Reference: Ground Water Registration Modification 10507

In the Matter of Ground Water	)	FINAL ORDER APPROVING
Registration Modification Application	)	RECOGNITION OF A MODIFICATION
T-10507, Columbia County	)	IN PLACE OF USE AND POINT OF
	)	APPROPRIATION

SUBJECT: Ground Water Registration Modification T-10507

Application for Groundwater Registration Modification Claim GR-2515

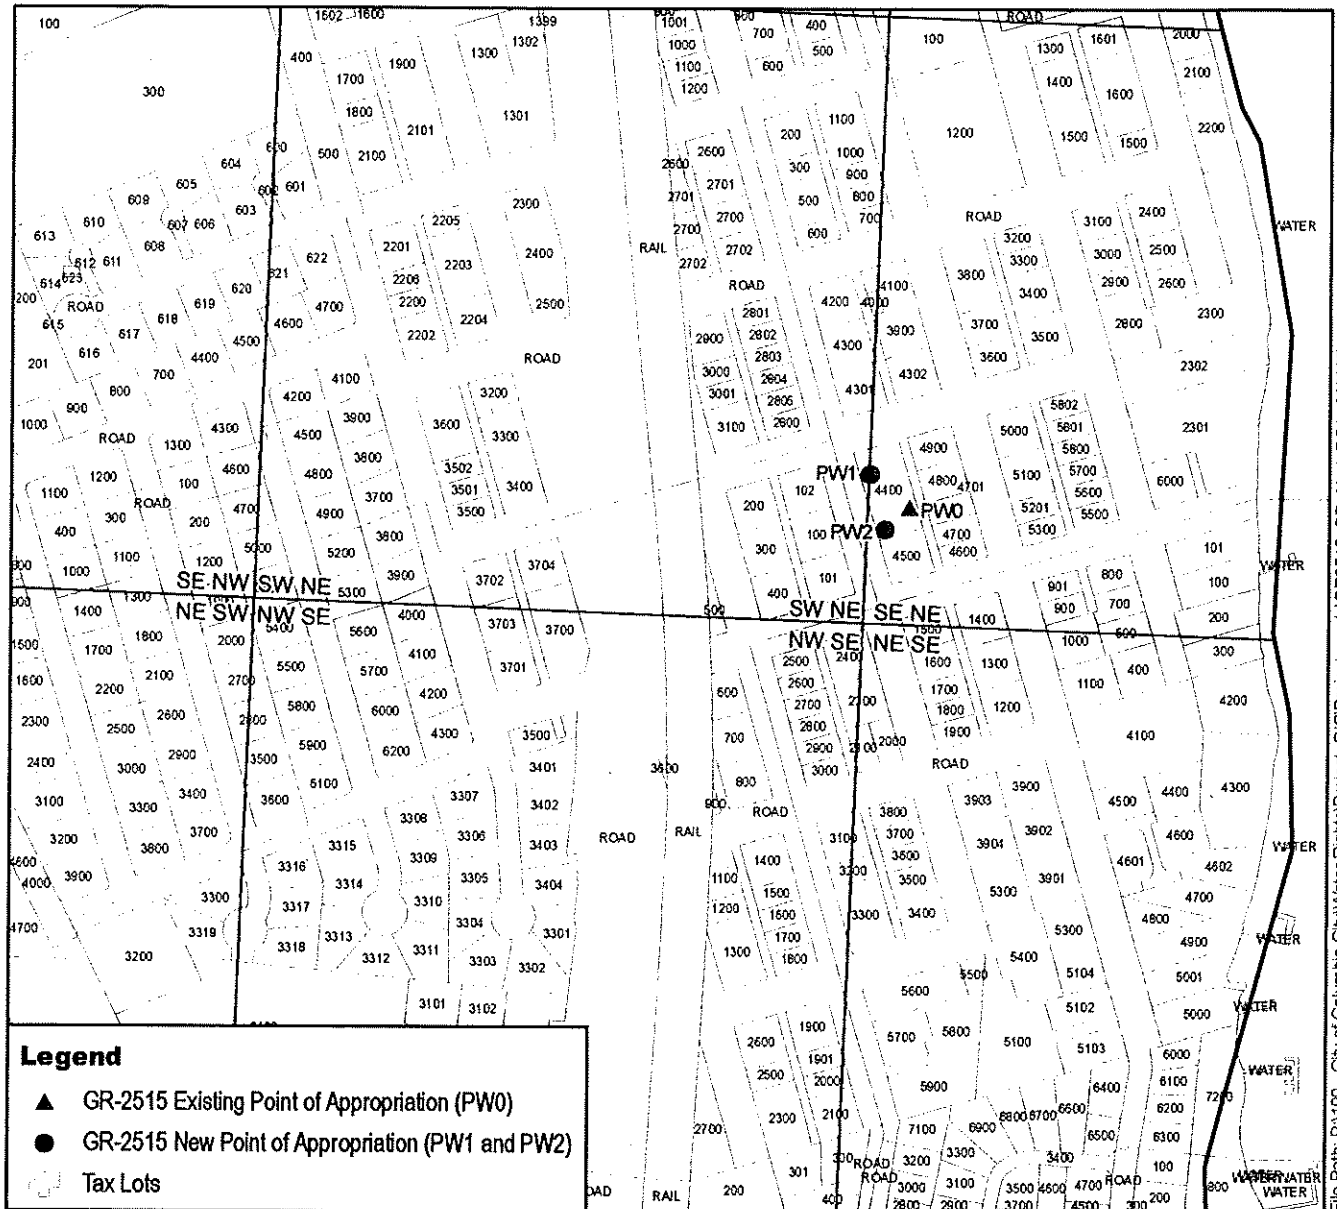
There are some problems with the application maps that need to be resolved before I can continue processing your application. Please submit revised maps that correct and/or include the following items, as required by OAR 690-382-0400 and 690-380-3100:

- OK. Rcvd. Corrected map on 2-6-08.
3. The location coordinates for the existing well (PW0) must be indicated on the large 11" x 17" map. While this information is shown on the small 8 1/2" x 11" map, a point for the existing well is not plotted on the small 8 1/2" x 11" map.
(NOTE: You could also correct this deficiency by adding a point on the small 8 1/2" x 11" map that identifies the existing well.)

- OK. See Corr. Map Rcvd. on 2-6-08.
4. The large 11" x 17" map must show quarter-quarter section lines.
OK. See Corr. Map Rcvd. 2-6-08.

Lisa – In response to your letter to Columbia City dated January 28, 2008, attached are the revised maps for the ground water registration application. Let me know if you have any questions or comments.

FIGURE 2

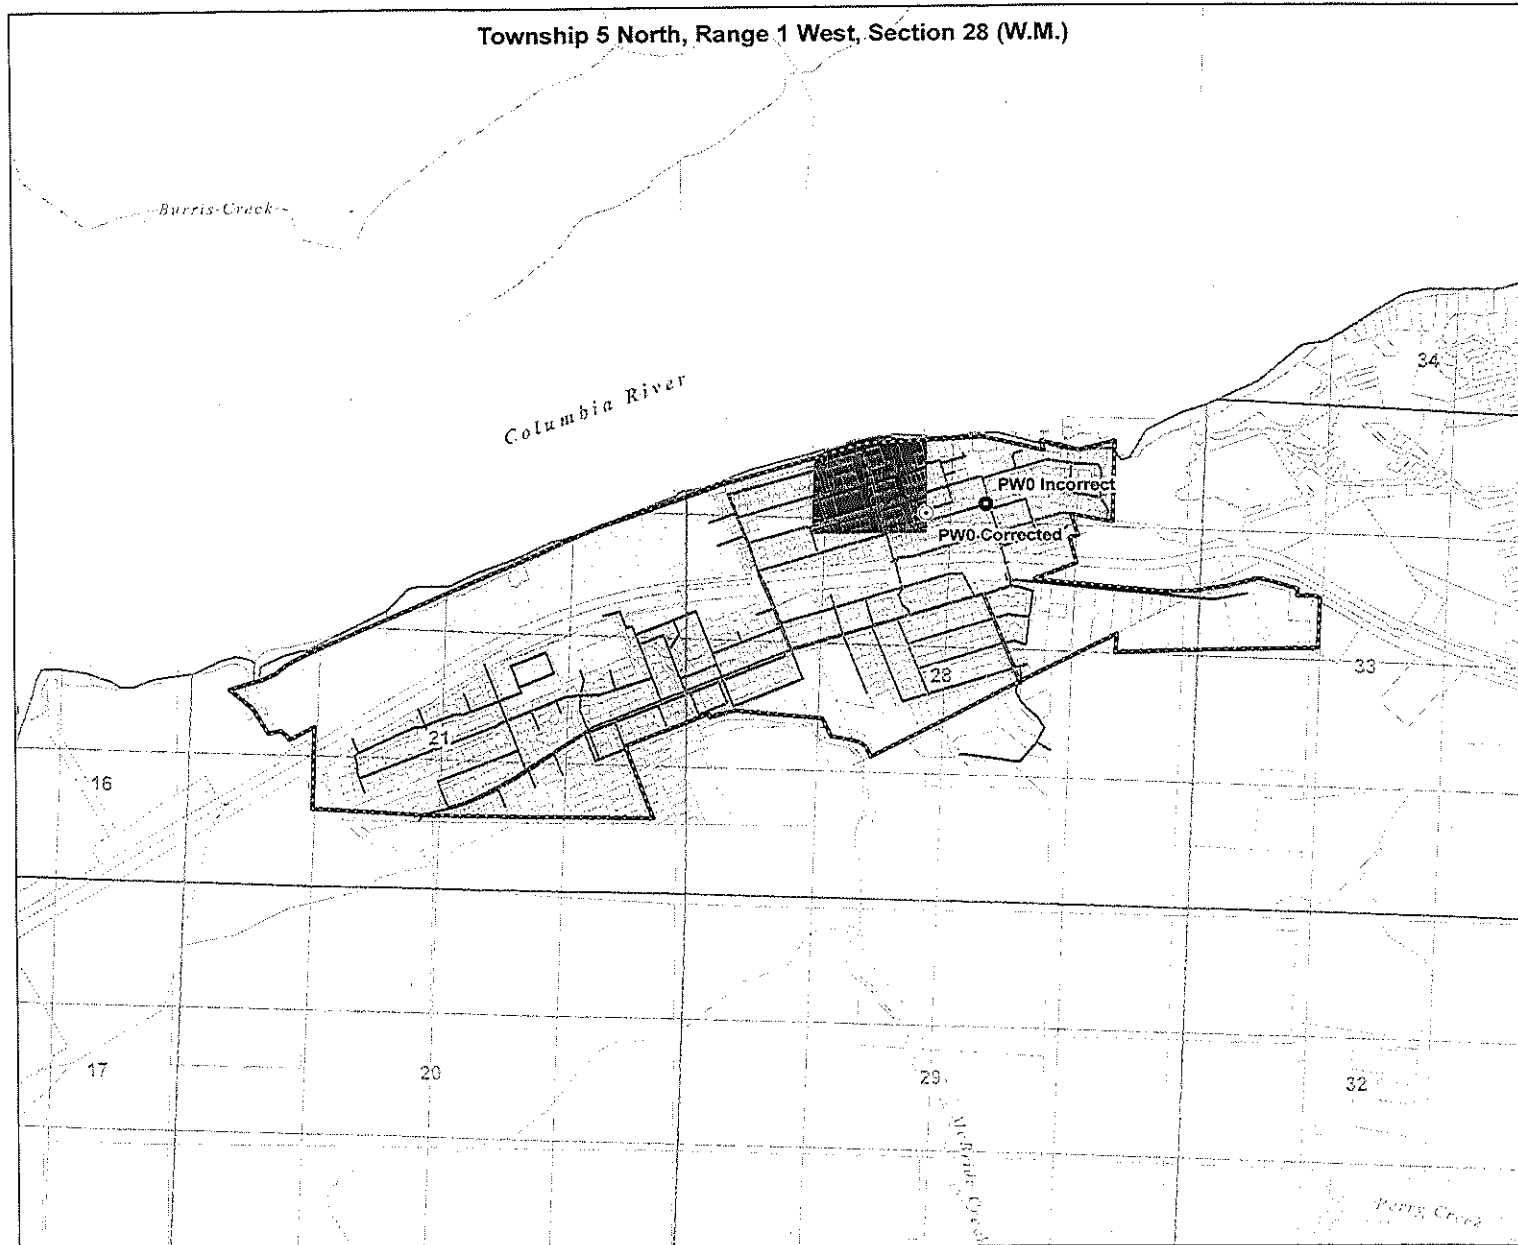
As part of my review, I found a discrepancy with the proposed place of use listing in the application (Pg. 7) and the application map (Figure 2 – 11 X 17). The application listing indicates that the entire NW ¼ of Section 28, T5N, R1W is to be included in the proposed place of use. Map Figure 2, however, appears to indicate otherwise. For the NW ¼ of Sec. 28, Map Figure 2 shows that only the NE ¼ NW ¼ and the SE ¼ NW ¼ are to be included in the proposed place of use. Please clarify which is correct.

If Map Figure 2 is correct, the proposed place of use listing on page 7 of the application needs to be amended so that it matches the map.

If, however, the proposed place of use listing in the application is correct, the map will need to be modified once more so that it agrees with the proposed place of use listing.

Lisa – I should have caught the discrepancy as well. Attached is the revised "location of place of use" table in the application. Figure 2 in the application is correct. Thanks, Eric

FIGURE 2

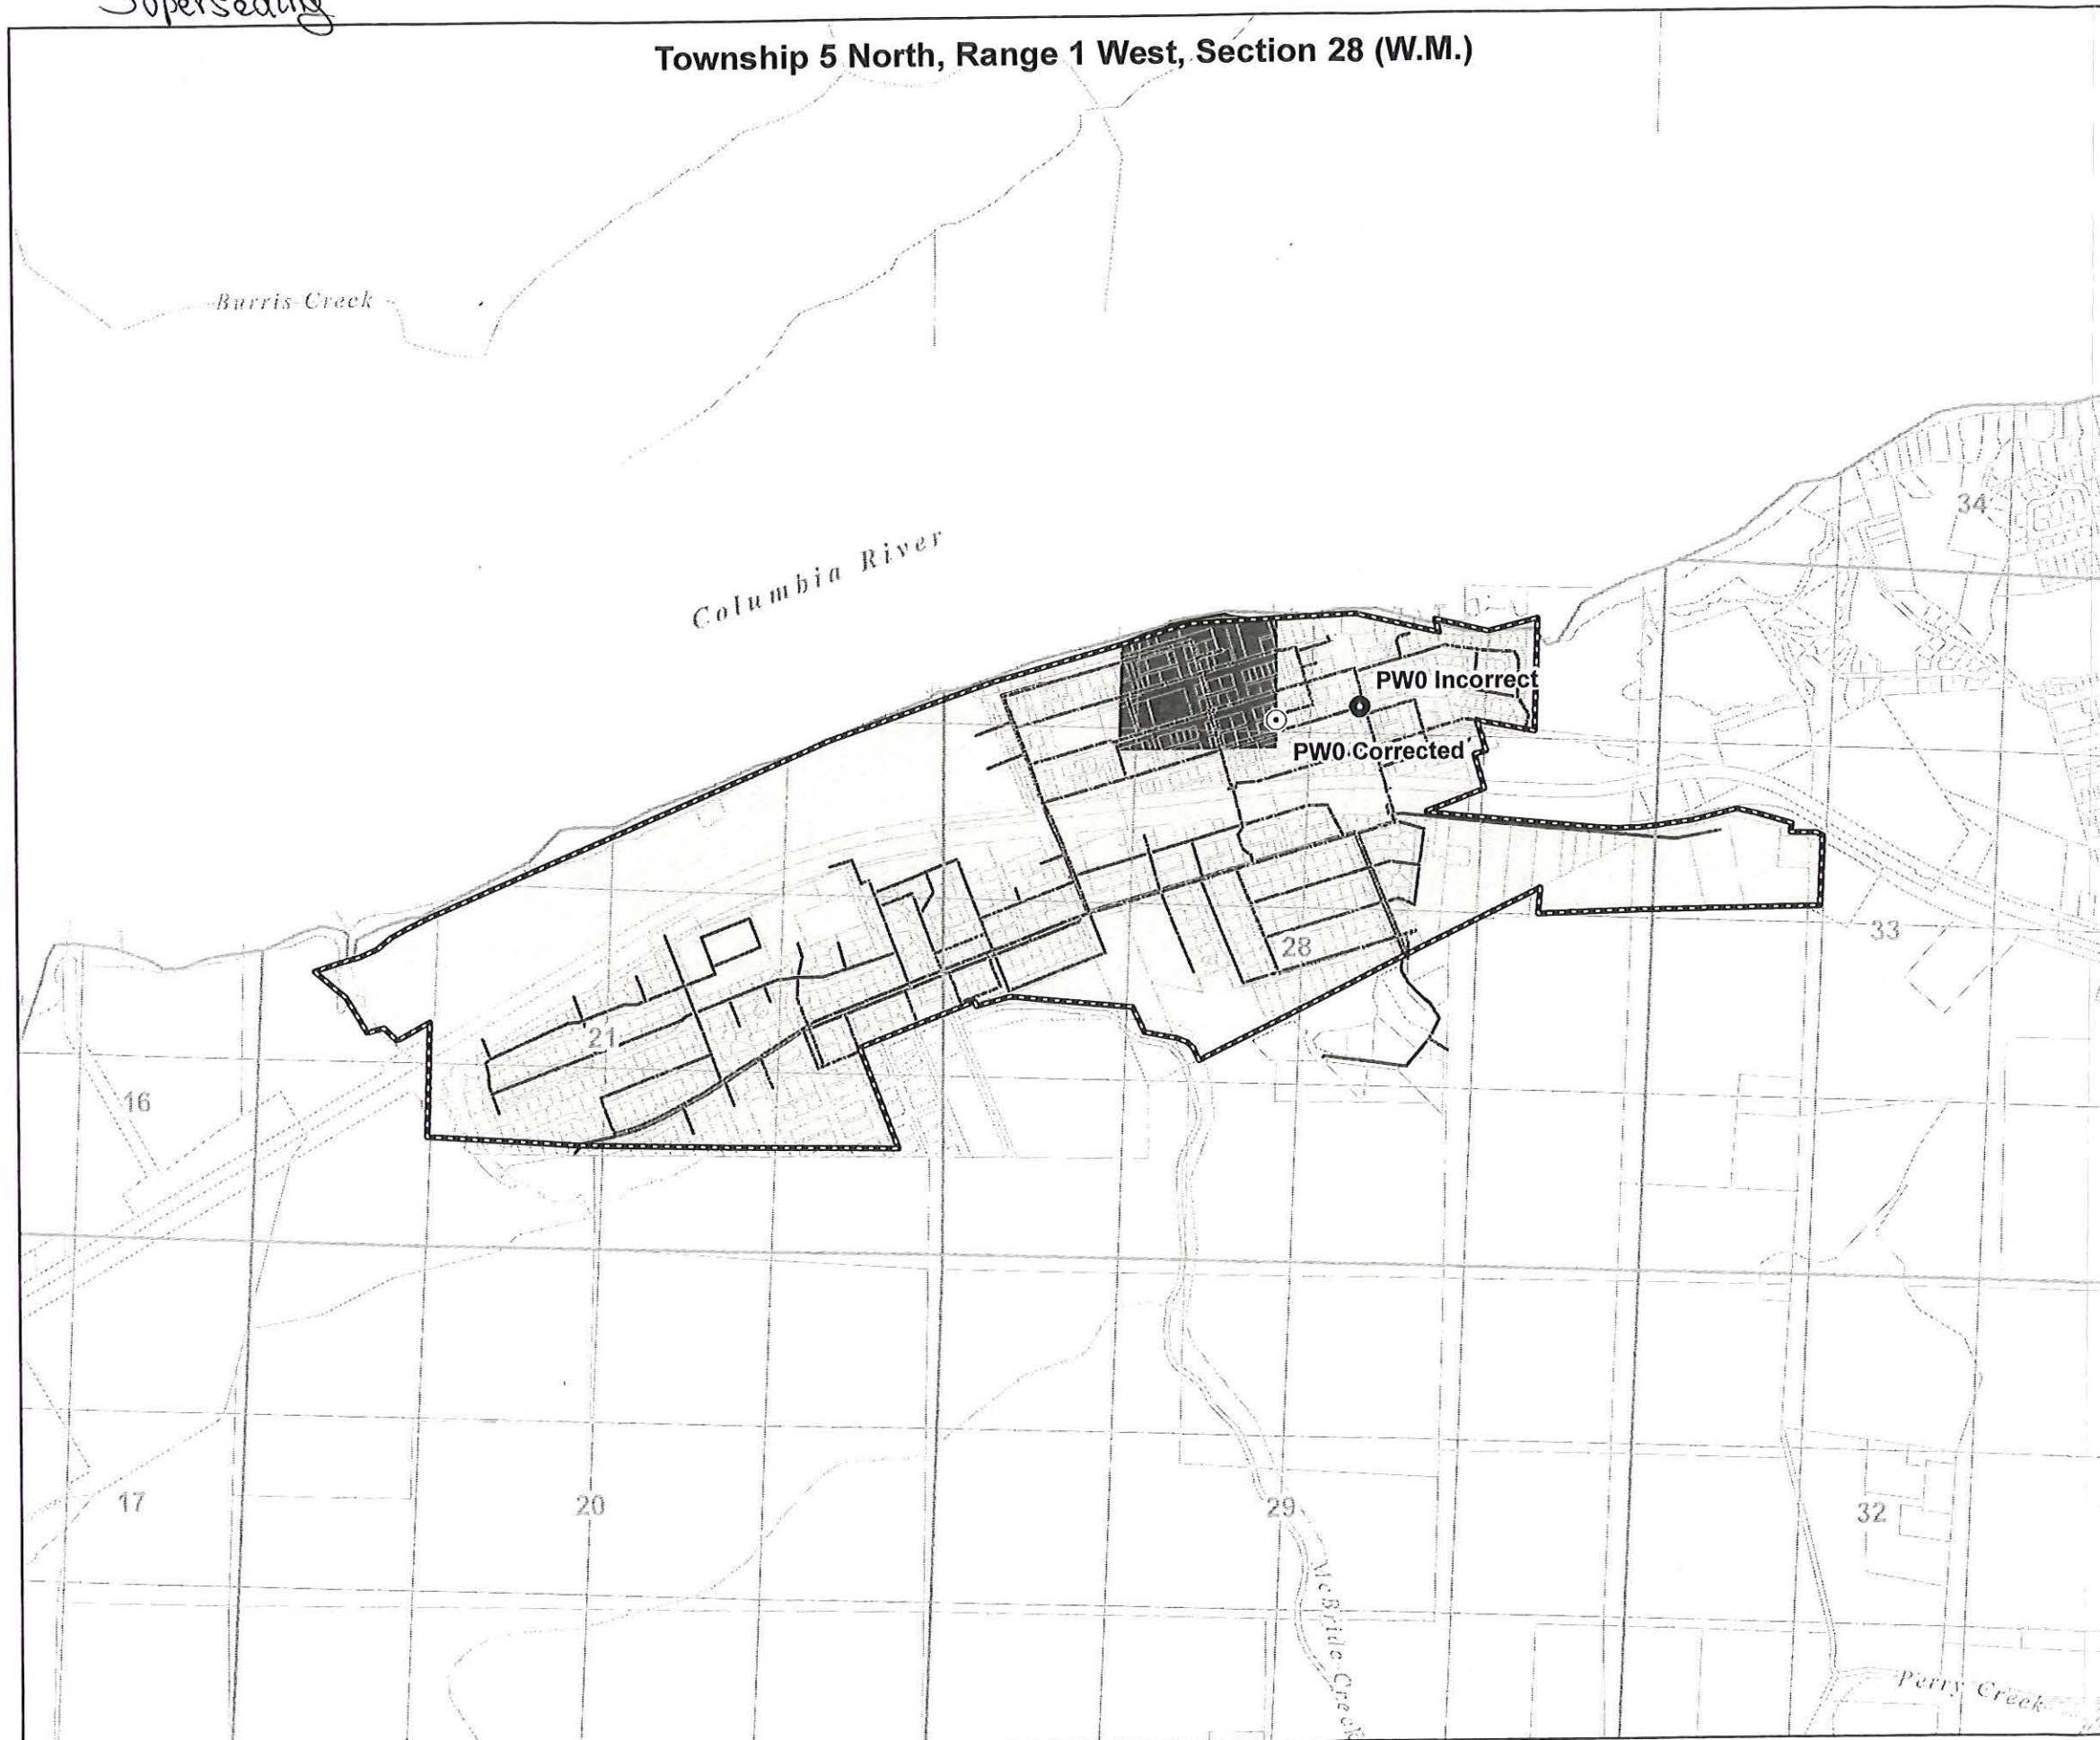
Superseded
by Revised
Map Rcvd
2-6-08.
